**RESOLUTION OF THE
WHITE MOUNTAIN APACHE TRIBE OF THE
FORT APACHE INDIAN RESERVATION**

Subject: Portable modulars for T.R. School.

PROPOSED SCHOOL BUILDINGS SITE PLAN

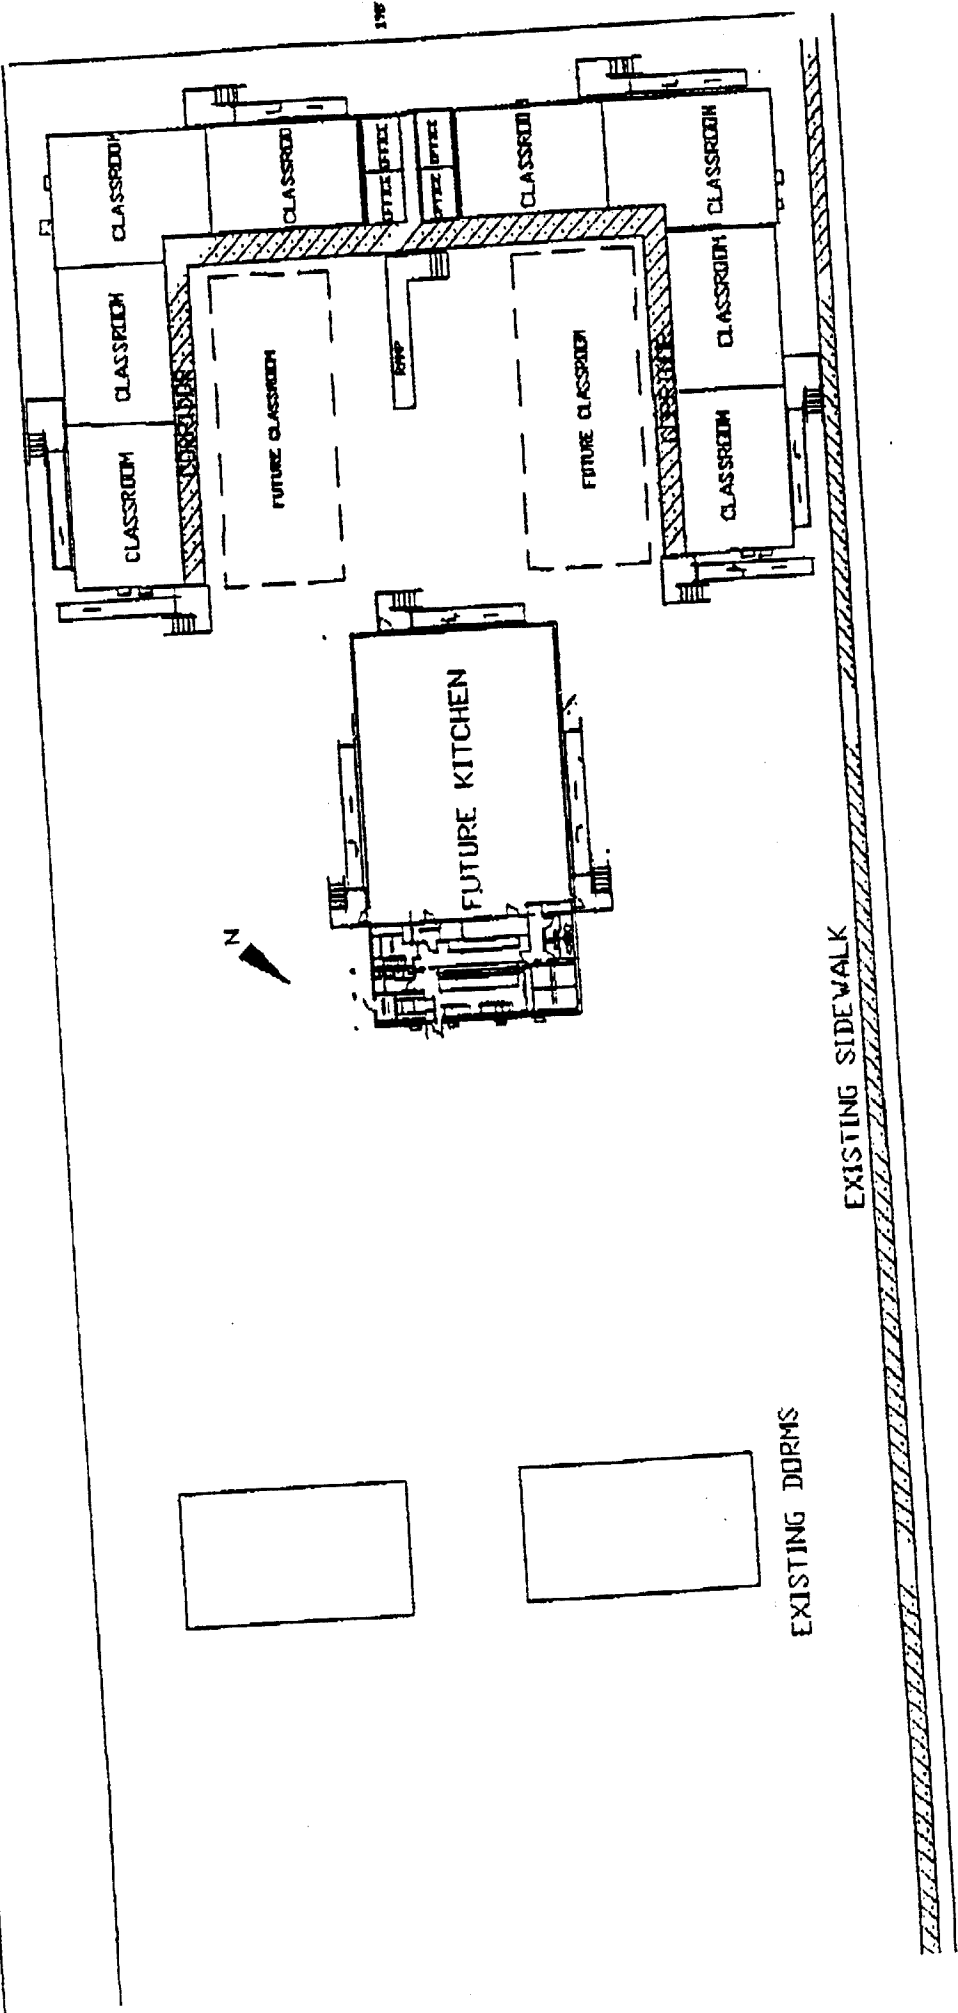
Due to possible construction delays on the agreed building plan for the T.R. School modulars, I am submitting this fax with a proposed revised building plan for your consideration.

I spoke to a modular builders manufacturer's representative concerning the school building layout plan. He said the proposed plan, with a corridor between classrooms, would increase the installation time and costs because the corridor section, not being normal factory prefabricated construction, would require special manufacturing and some on site construction.

The manufacturer said that they normally fabricate the total buildings, or sections, at the factory and deliver to the site for final section connections and tie-down.

I have revised the original plan and included the desired corridor and additional space for offices. The corridor is now built into a wider classroom modular for ease of manufacturing.

The new plan arrangement will also provide for the needed future additions of science laboratories, or other required spaces, as expressed by the school Principal. The location of the future kitchen can be wherever you want it.

At this time, I am considering the installation of a flat roof for ease in bring the different modular roof sections together. Do you have any objections?
